REVIEW NOTES
BRATTLEBORO BRO 1442(35) – BRIDGE NO. 7
TEMPORARY BRIDGE DRAWINGS
May 9, 2014

RE: Temporary Traffic Control Signage Drawings received from Renaud Bros. Inc on 5/30/2014.

This submittal review is for sheets 1-2, inclusive, of the
 “Brattleboro(35)-TrafficControlSignage_review” submittal received on 5/30/2014.

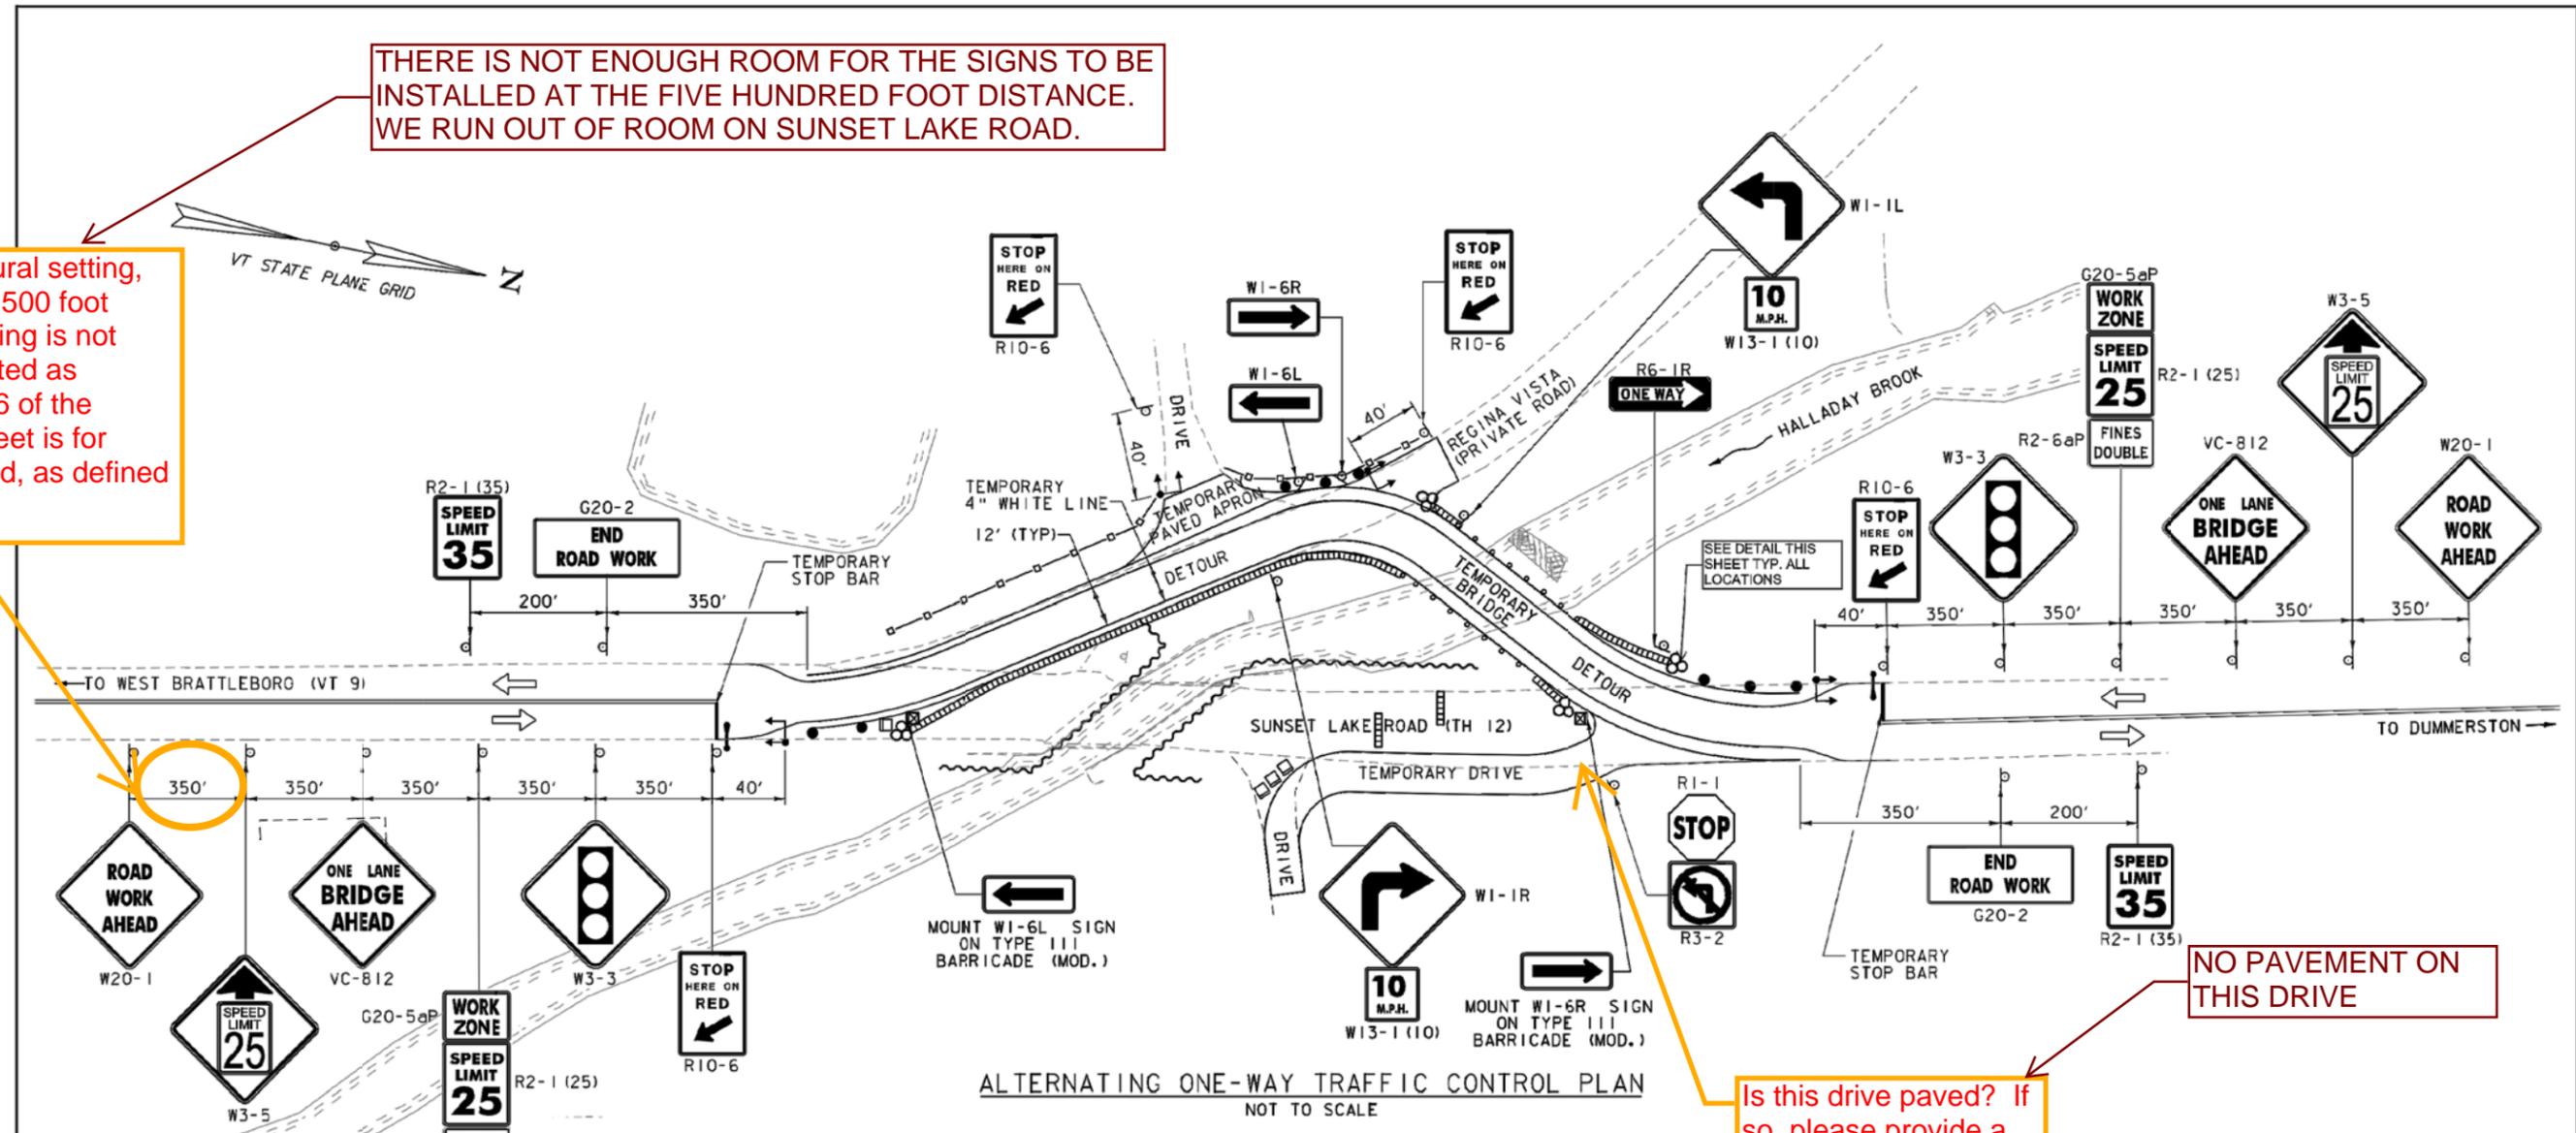
Being this is a rural setting, curious why the 500 foot (TYP) sign spacing is not being implemented as outlined in Part 6 of the MUTCD? 350 feet is for urban high speed, as defined in Table 6H-3.

Is this drive paved? If so, please provide a 24" stop bar.

THERE IS NOT ENOUGH ROOM FOR THE SIGNS TO BE INSTALLED AT THE FIVE HUNDRED FOOT DISTANCE. WE RUN OUT OF ROOM ON SUNSET LAKE ROAD.

NO PAVEMENT ON THIS DRIVE
